**ADDENDUM NO. 1**

DATE: SEPTEMBER 23, 2021  
TO: ALL BIDDERS  
PROJECT: ITB PW 57-21 – OKALOOSA ISLAND – SOUND SIDE ACCESS NO. 2  
BID TIME AND DATE: 3:15 PM LOCAL TIME, October 6, 2021 (*NEW DATE & TIME*)

#### ITEM NO. 9 – DRAWING SHEET NUMBERS 13 AND 14

**WAVE ATTENUATOR DETAILS**  
Soundside Access No. 2 Boat Basin and Amenities  
Okaloosa County Board of County Commissioners  
1250 N. Eglin Parkway, Shalimar, Florida 32579

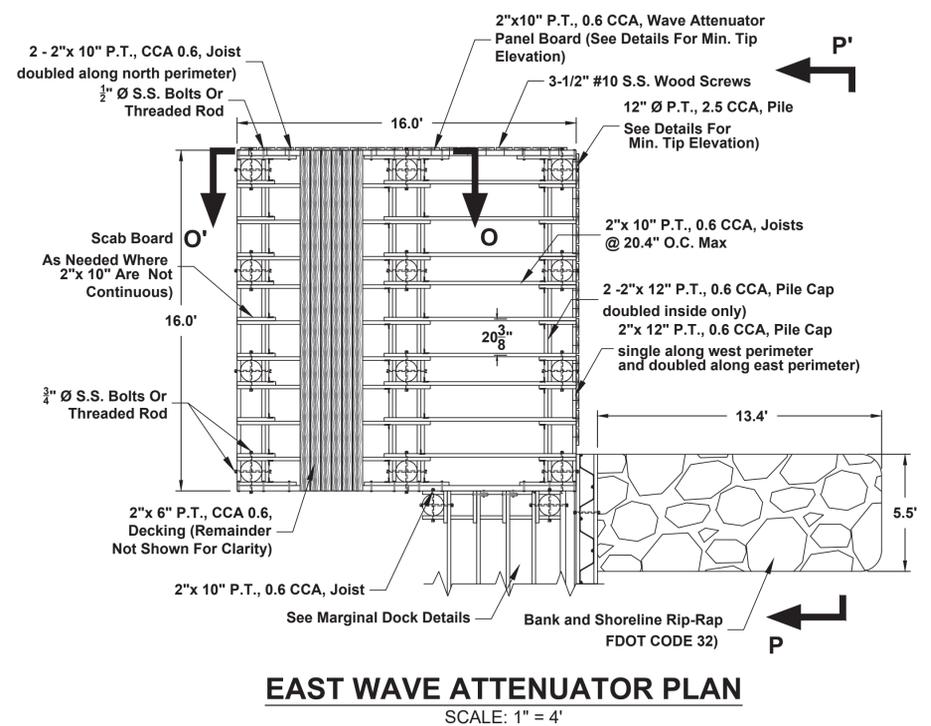
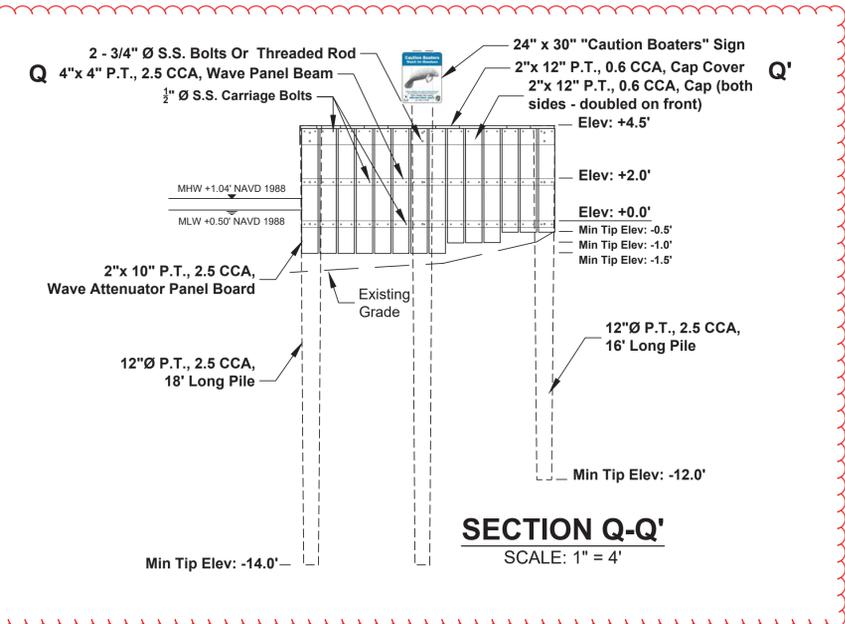
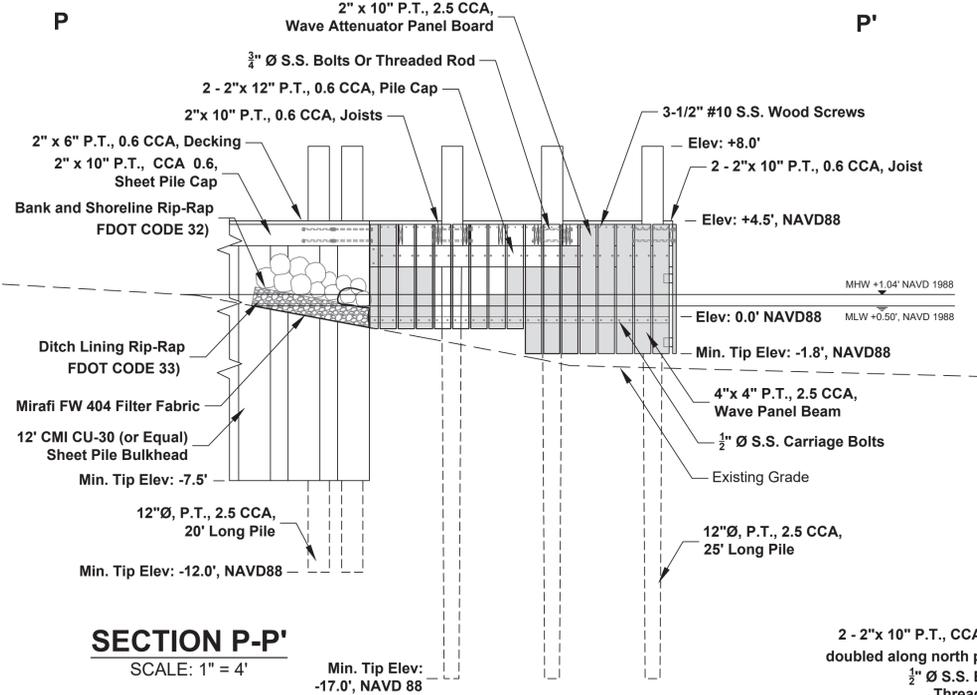
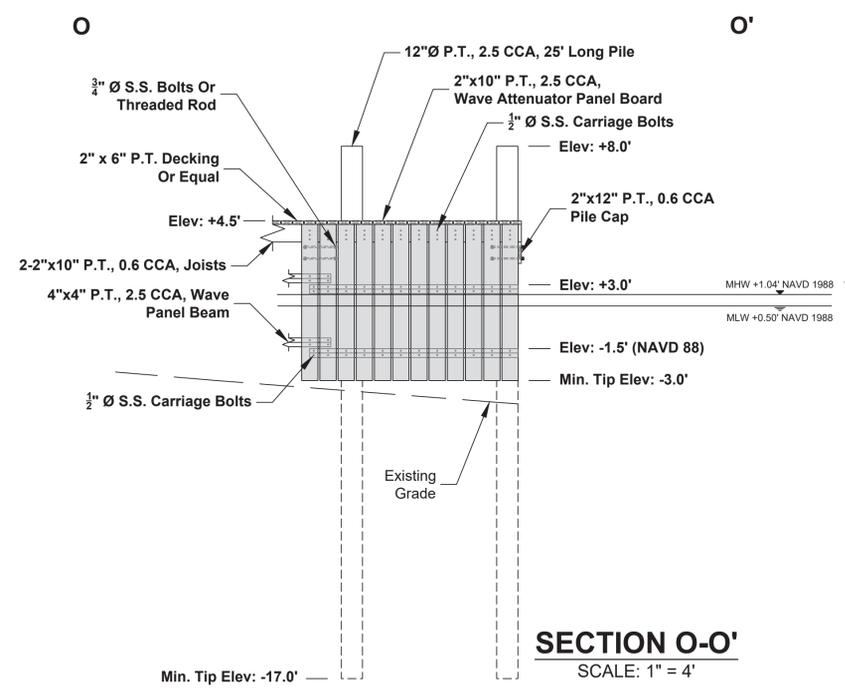
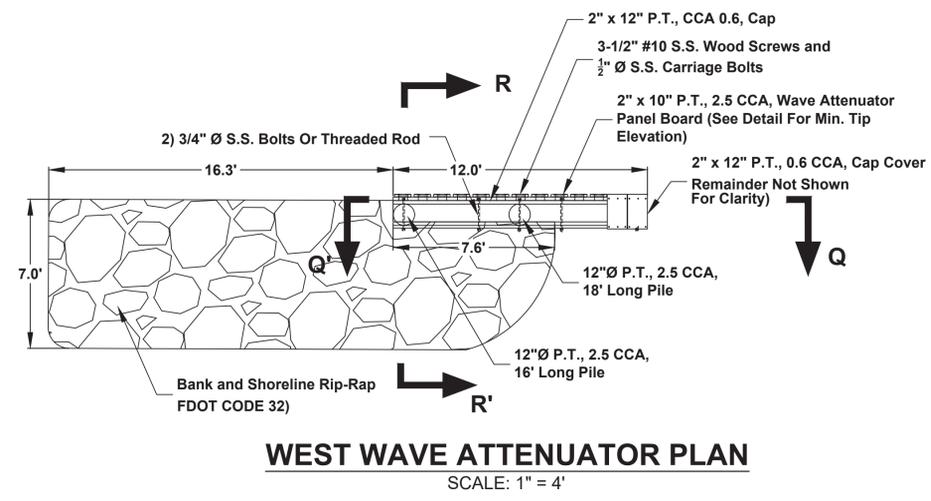
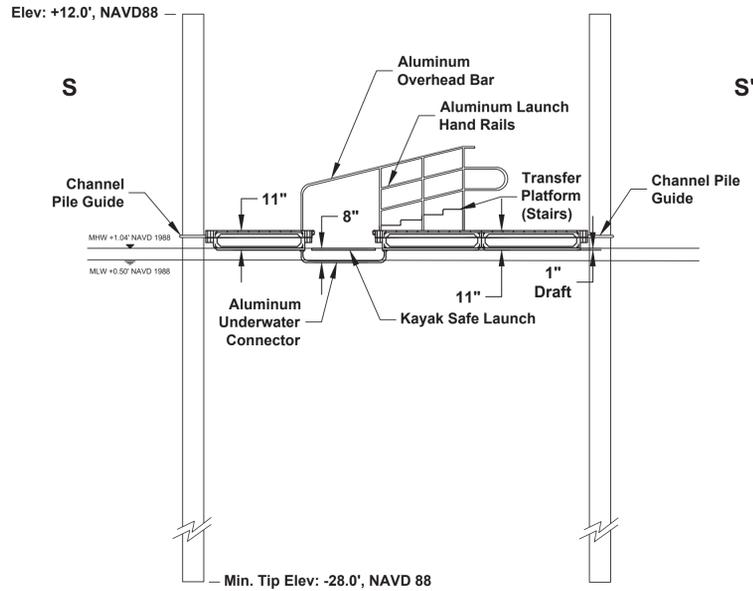
The following describes the changes indicated on SHEETS 13 and 14. The length of the proposed gangway has been increased from 16 feet to 36 feet to meet ADA requirements. Measurement and payment for the ramp will be included in Bid Item No. 14 ADA Kayak and Canoe Launch. The wood cap along the 57 feet of replacement bulkhead along the southern edge of the basin will be replaced with a reinforced concrete pile cap. Measurement and payment will be on a linear foot basis and will be included in Bid Item No. 57. Elevation of the western wave attenuator raised to +4.5 feet NAVD 88 to be consistent with the eastern wave attenuator. "Caution Boaters" manatee sign added to western wave attenuator. Measurement and payment of the manatee sign will be included in the Bid Item No. 13 Wave Attenuators (east and west).

Replace existing Sheet Nos. 13 and 14 with revised sheets 13 and 14 marked Addendum 1. The changes have been identified by a revision cloud.
